MEMORANDUM

**Re: Adequacy Review of Exhibit 6.5 – Geotechnical Stability Adequacy Response
Aggregate Industries; Tucson South Resource; File No. M-2004-044; AM-01**

The Division of Reclamation, Mining and Safety (Division/DRMS) has reviewed the Slope Stability Analysis adequacy response by Tetra Tech dated July 3, 2019 for the Tucson South Resource 112c permit amendment application (AM-01). The Applicant will need to address the following adequacy items identified in the review:

Project Tucson South AM

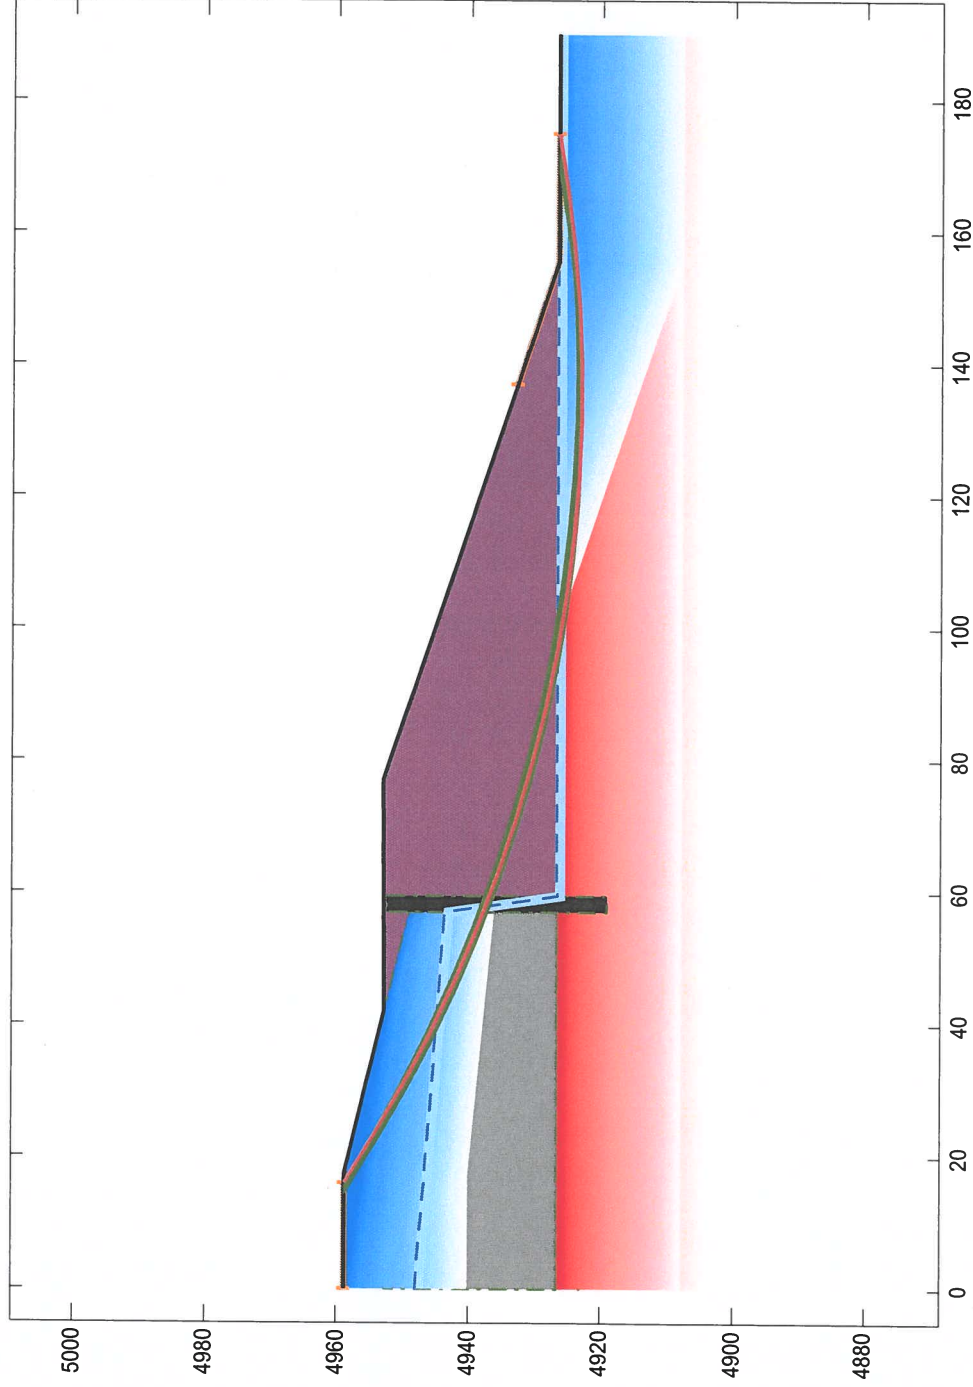
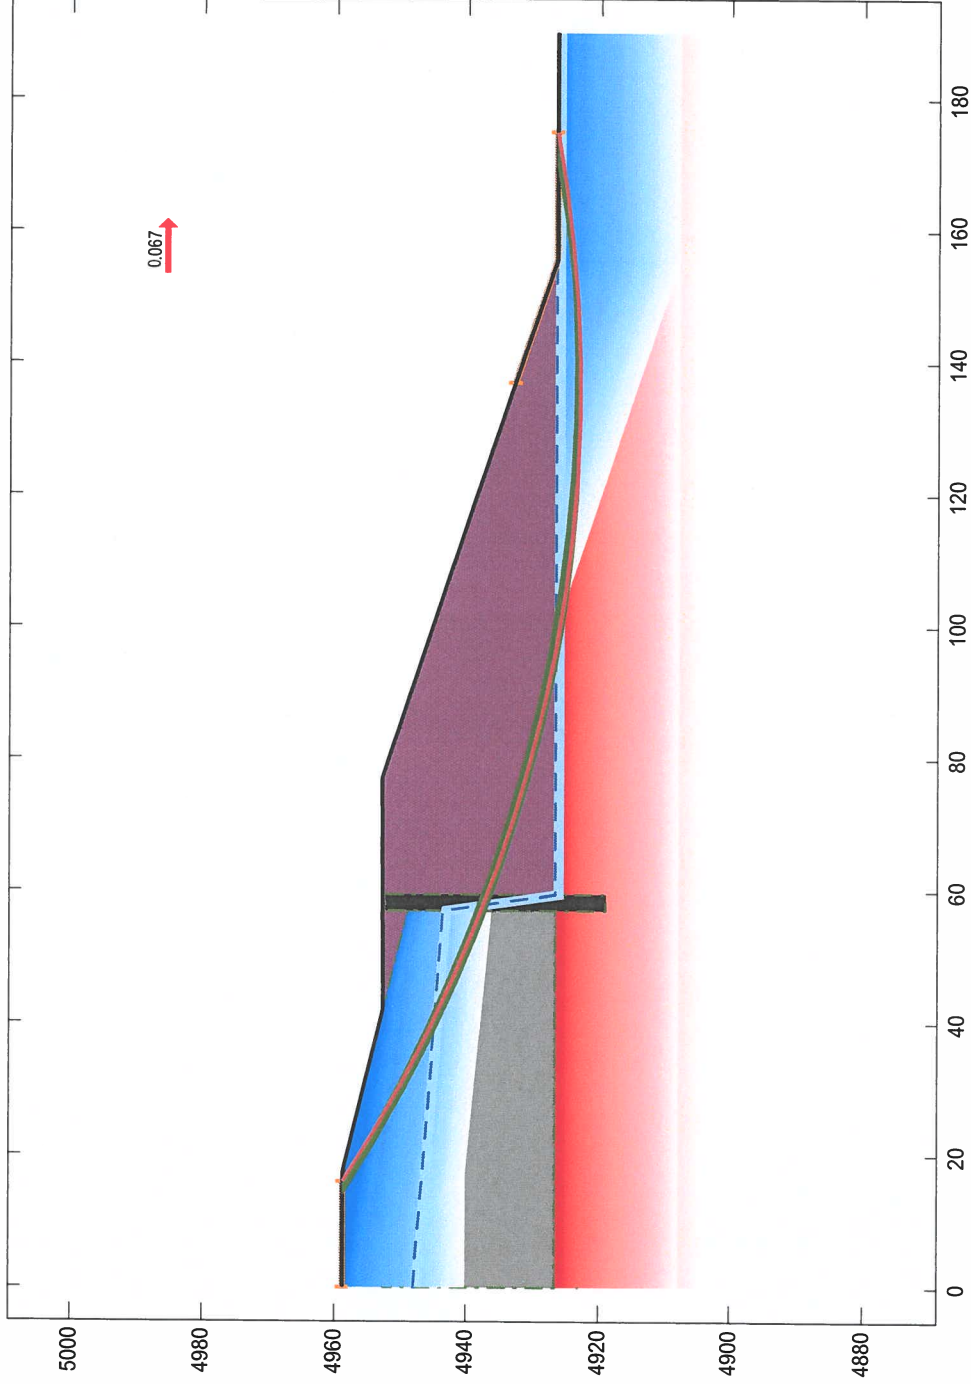
3. The Applicant modeled the Figure F analysis with a 35 feet offset from the power pole easement to the top of the mine slope. The Exhibit C-3 Map indicates the Applicant modeled a 45 feet offset. Please explain this discrepancy and revise the Figure F models and/or the Exhibit C-3 Map accordingly.

Project Tucson South AM
G-1 - Static - Fill
File: G:\My Drive\1 - My Projects\Google\8 Galena - Stability Analysis Models\Tucson South\Tucson Figure G-1 Static Fill.gmf

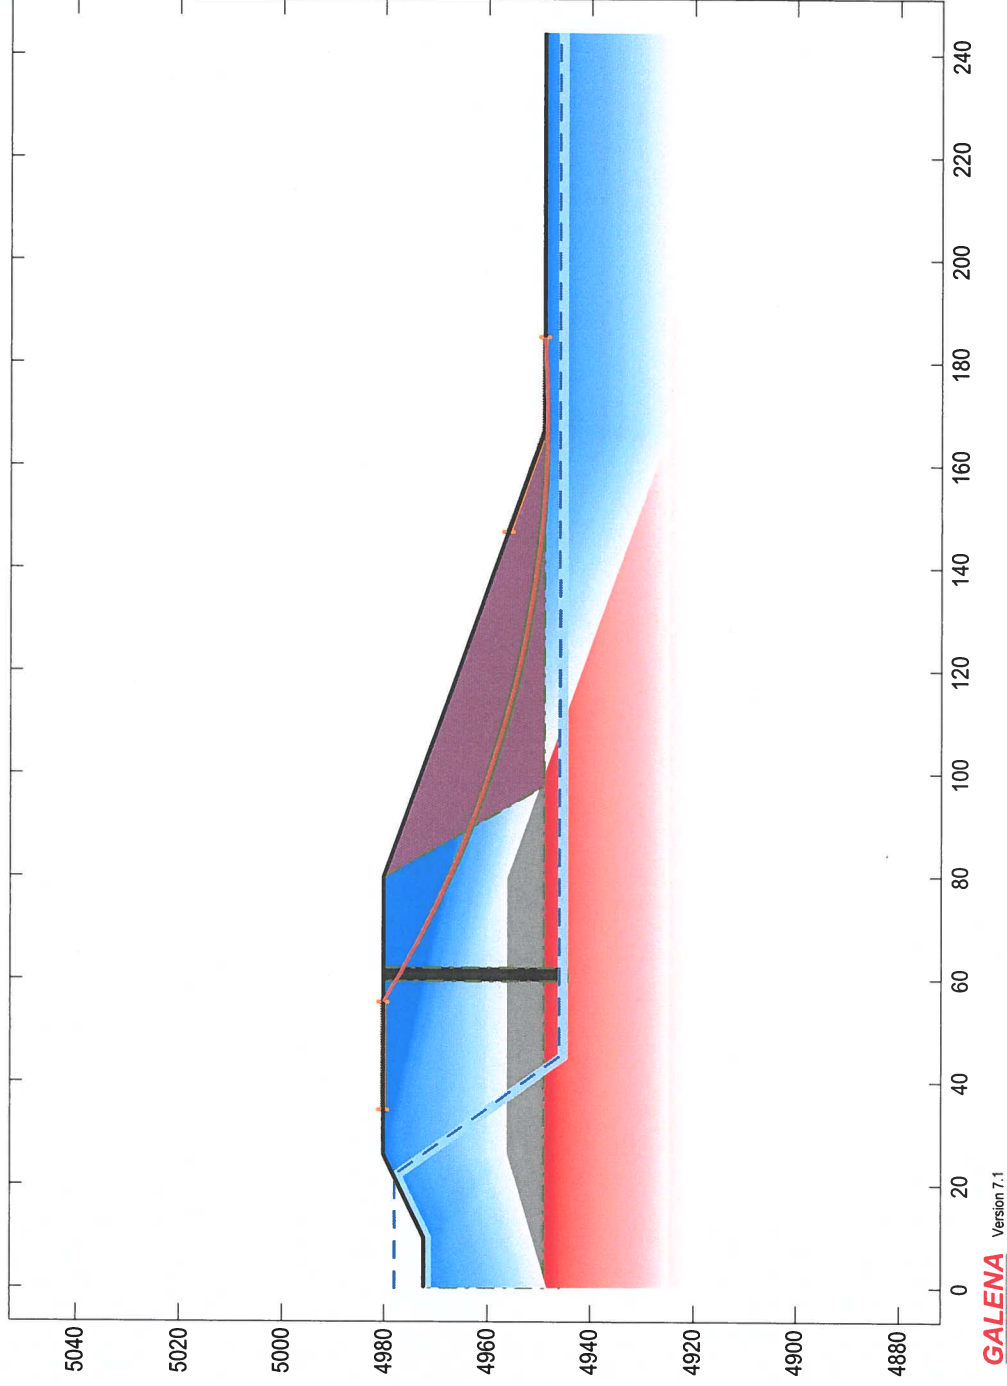
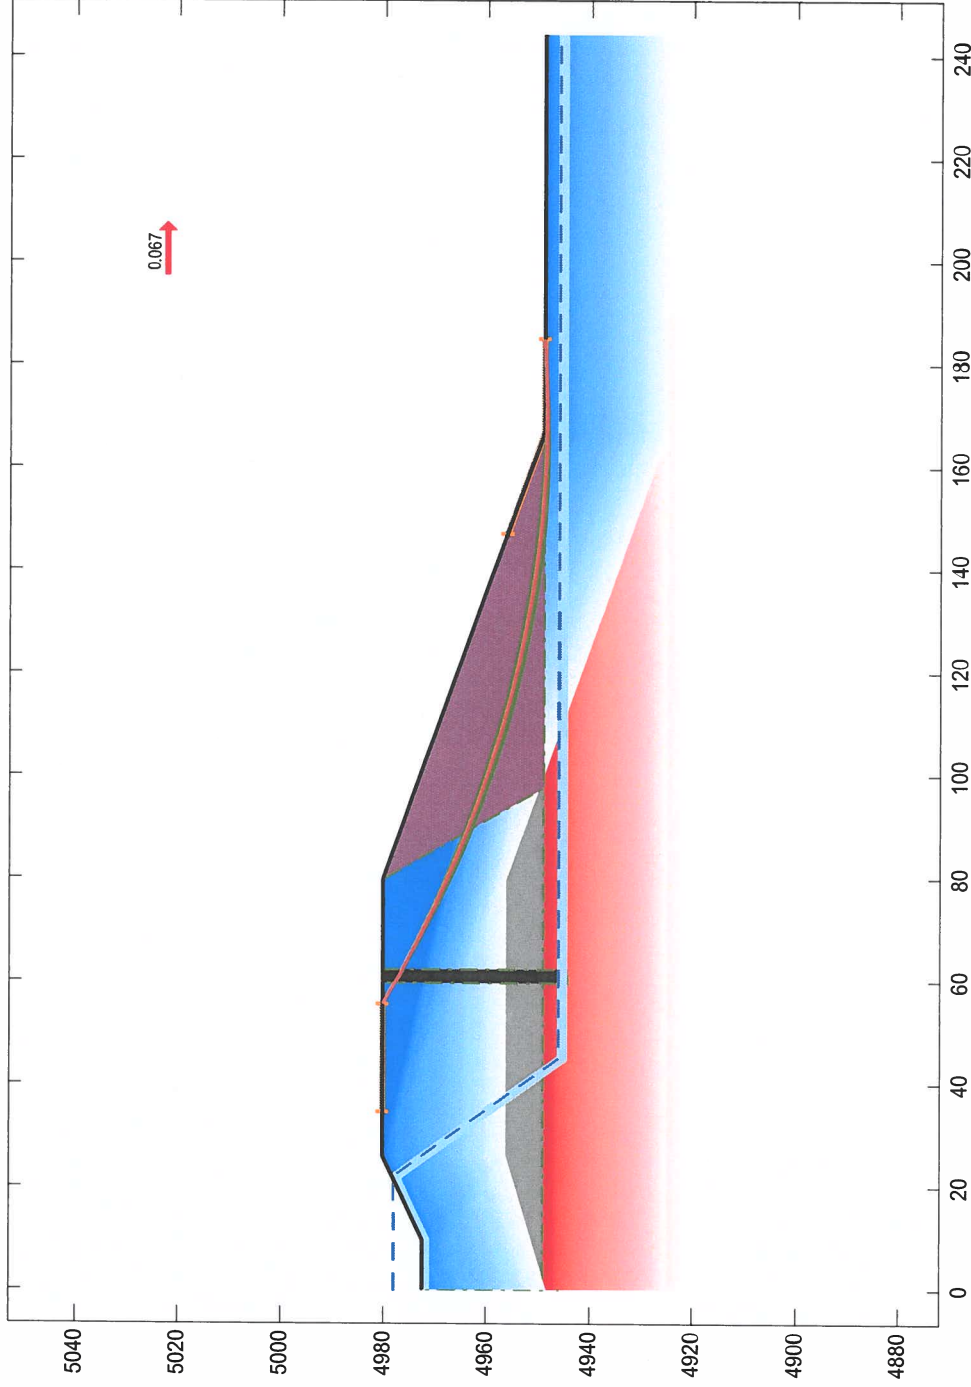
4. The Applicant modeled the Figure G analysis with a 53 feet offset from the Brighton Ditch to the top of the mine slope. The Exhibit C-3 Map indicates the Applicant modeled a 35 feet offset. Please explain this discrepancy and revise the Figure G models and/or the Exhibit C-3 Map accordingly.

Project Tucson South AM
H-1 - Static

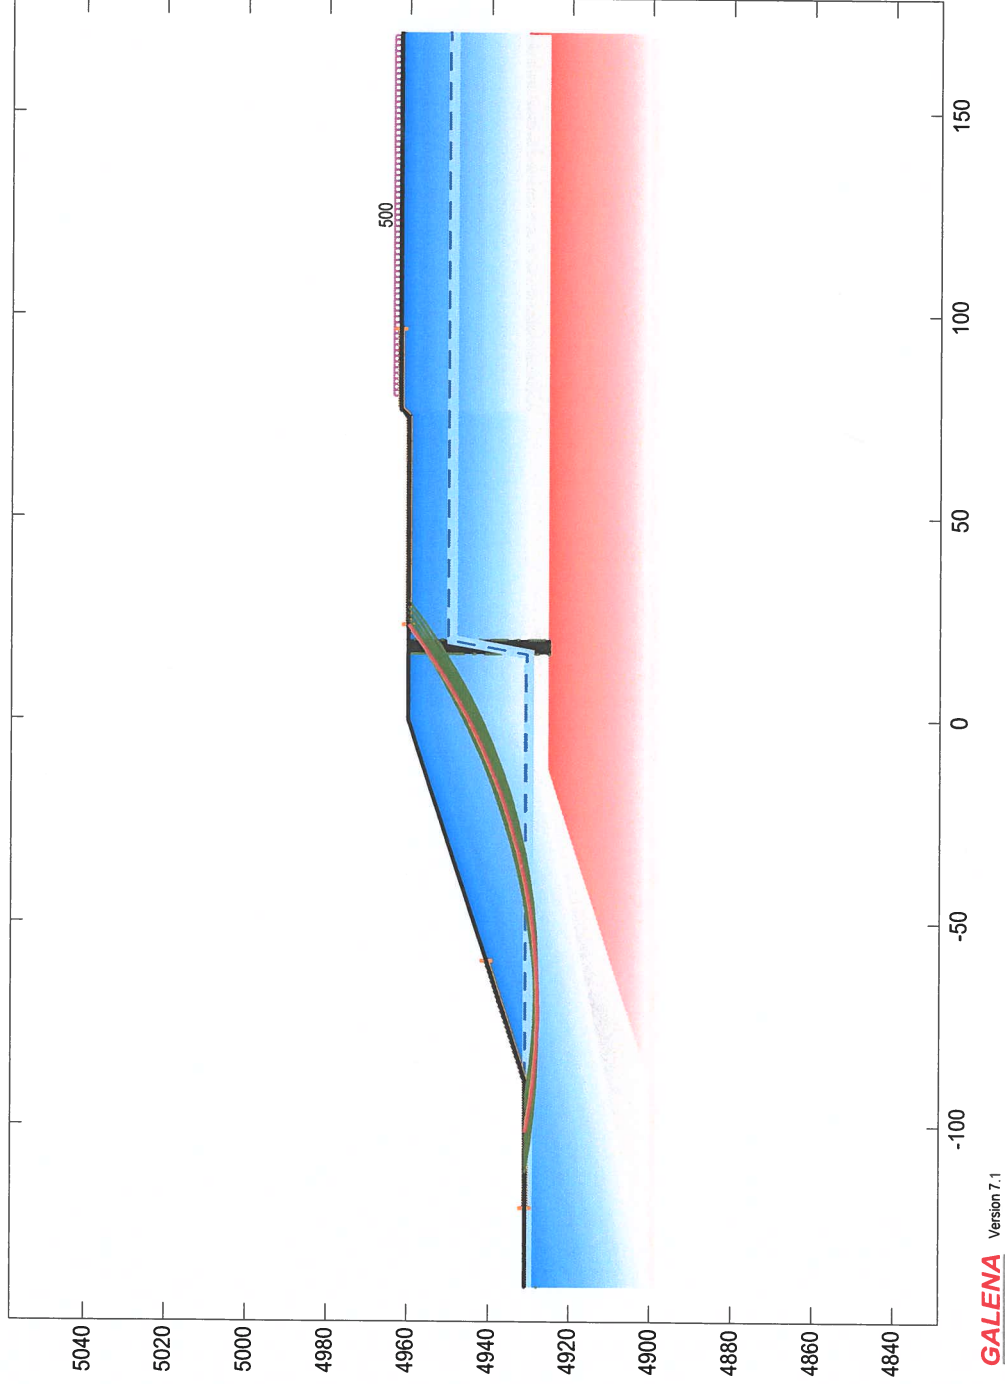
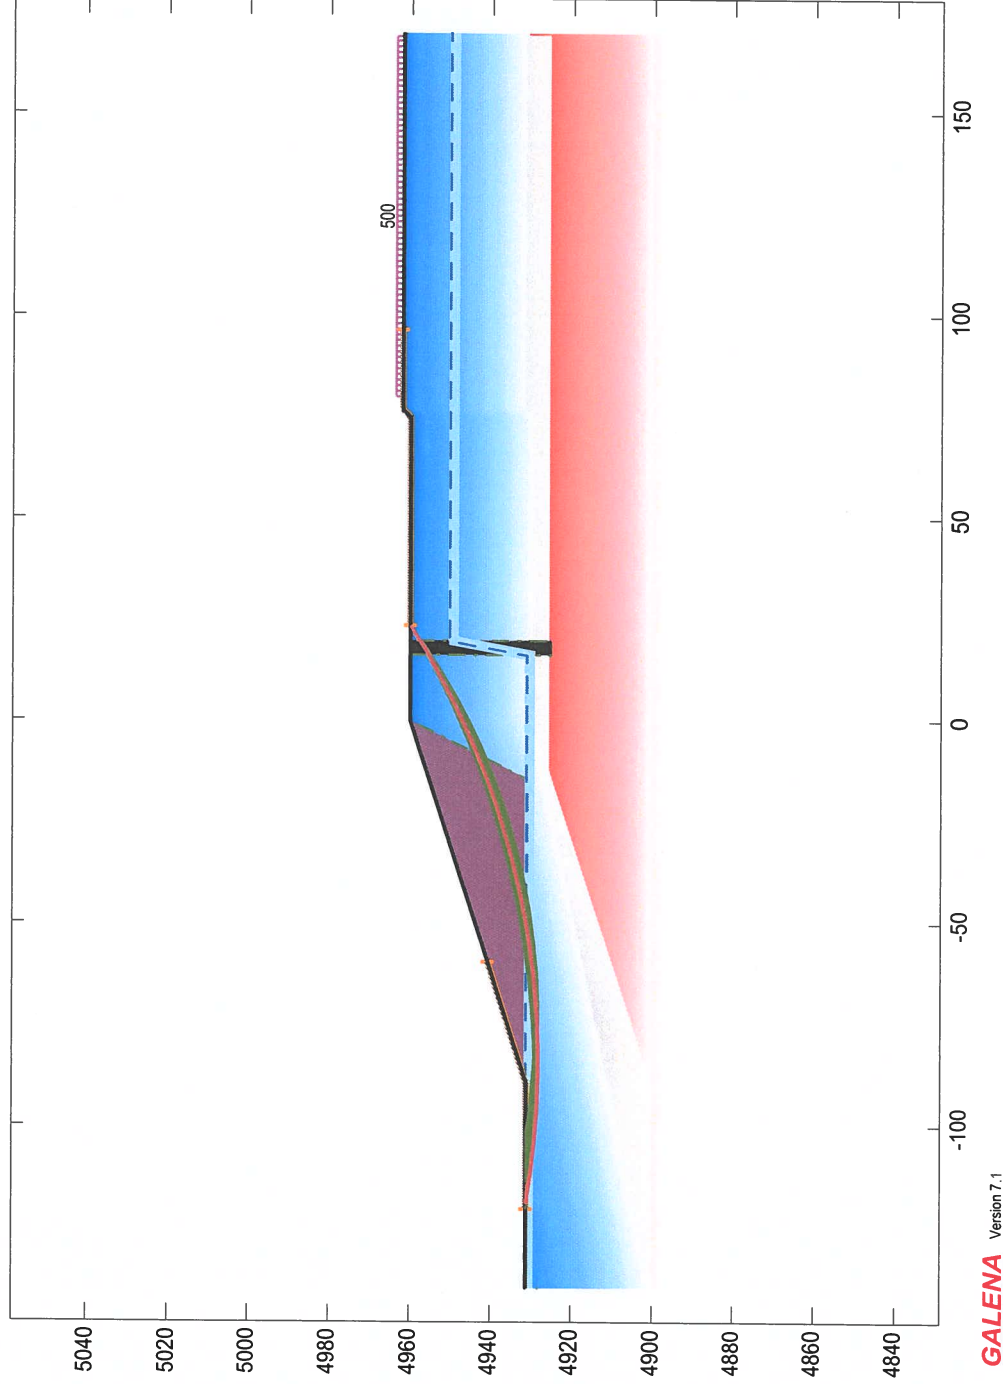
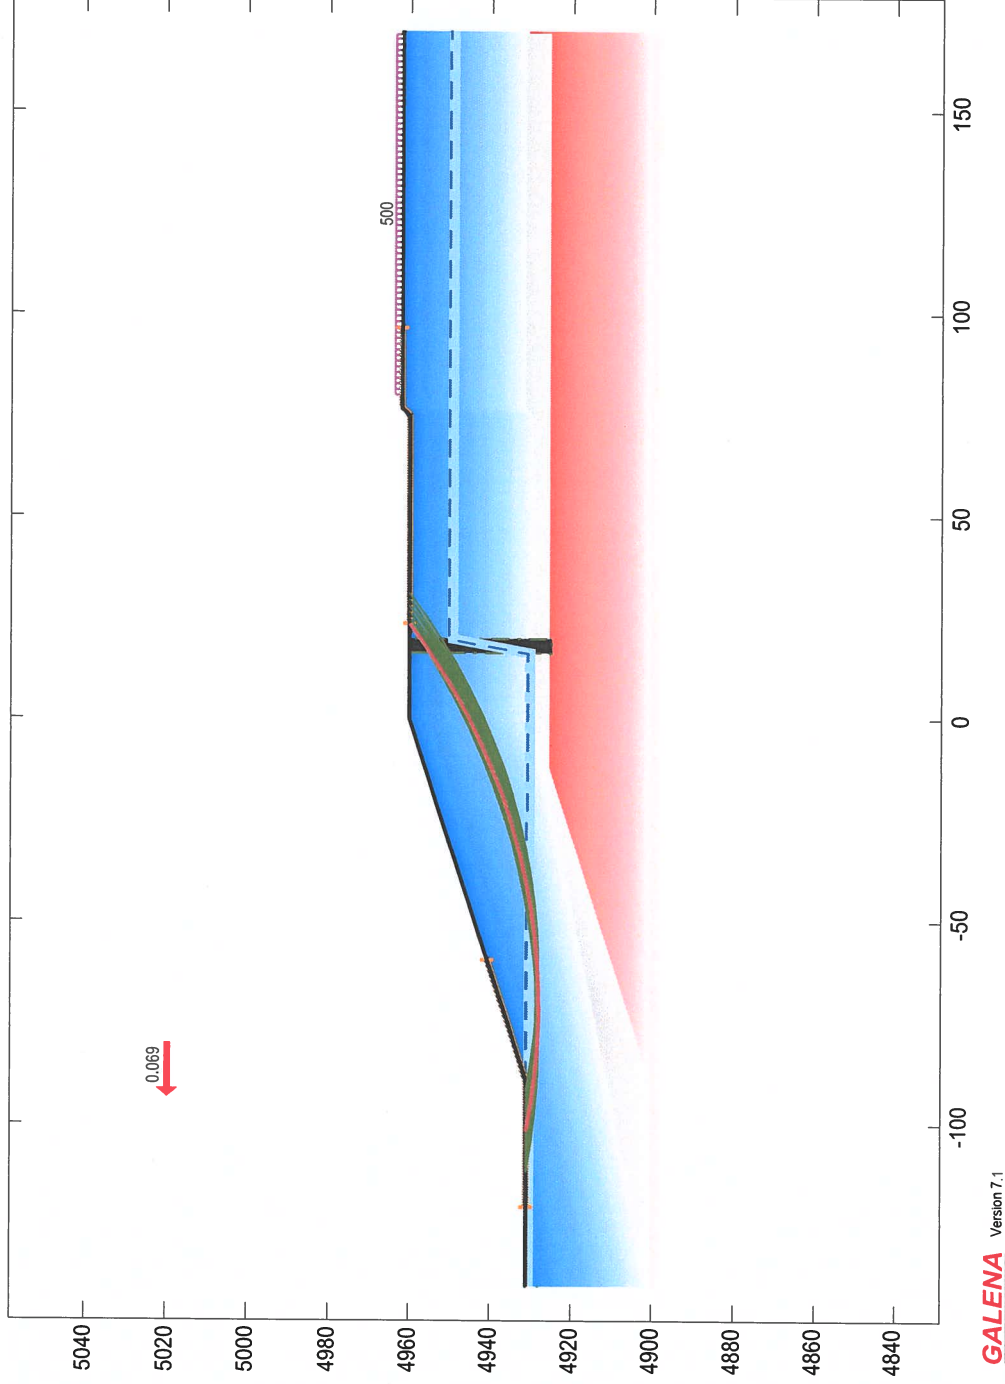
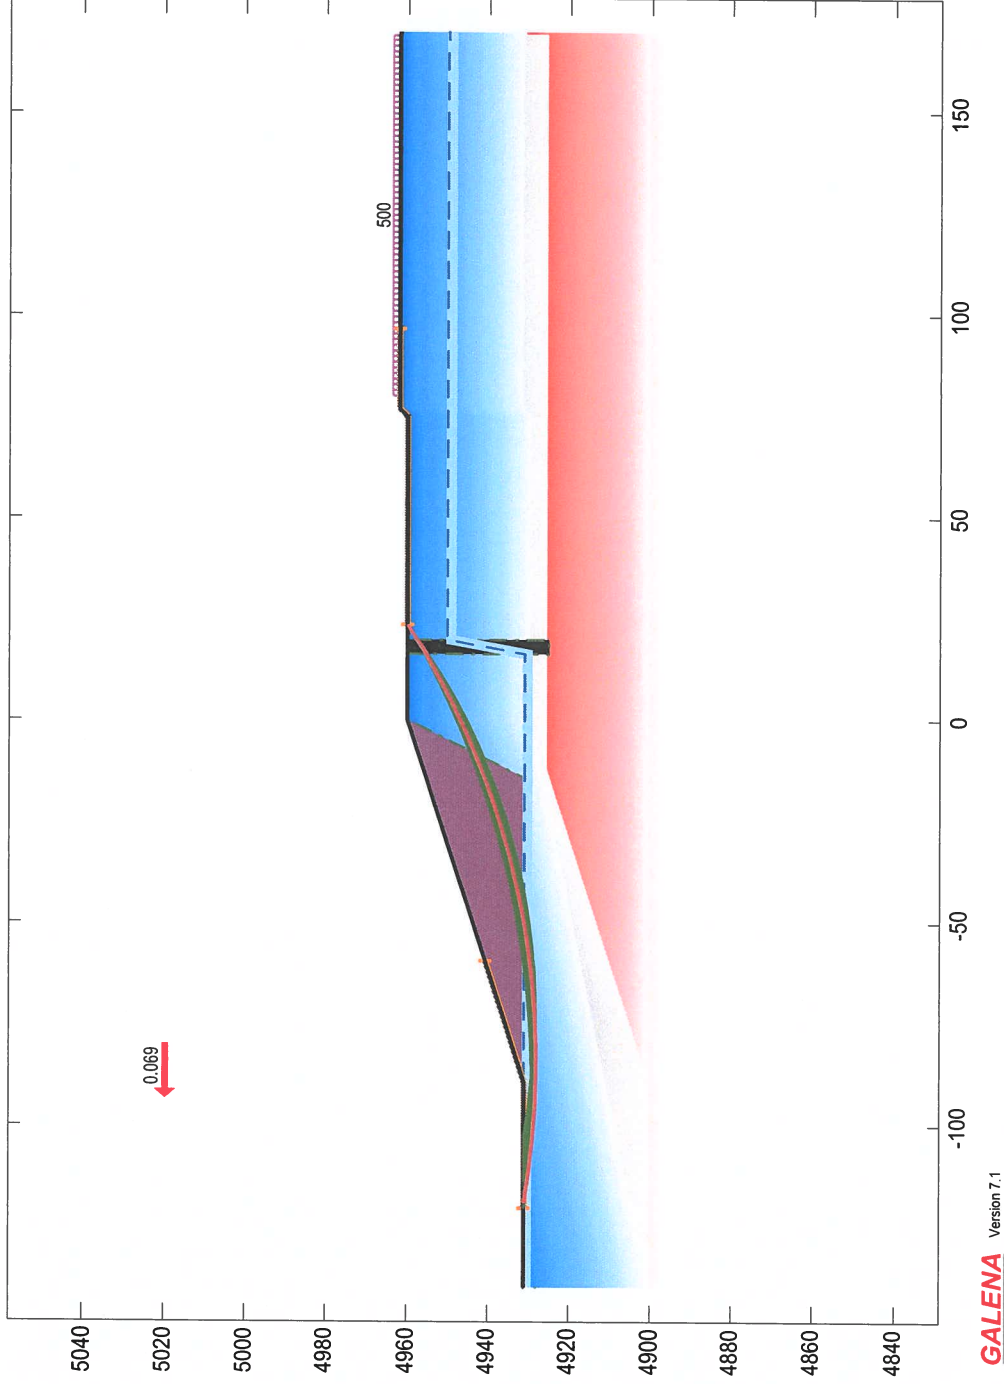
5. The Applicant modeled the Figure H analysis with a 75 feet offset from the edge of Highway 7 to the top of the mine slope. The Exhibit C-3 Map indicates the Applicant modeled a 106 feet offset. Please explain this discrepancy and revise the Figure H models and/or the Exhibit C-3 Map accordingly.
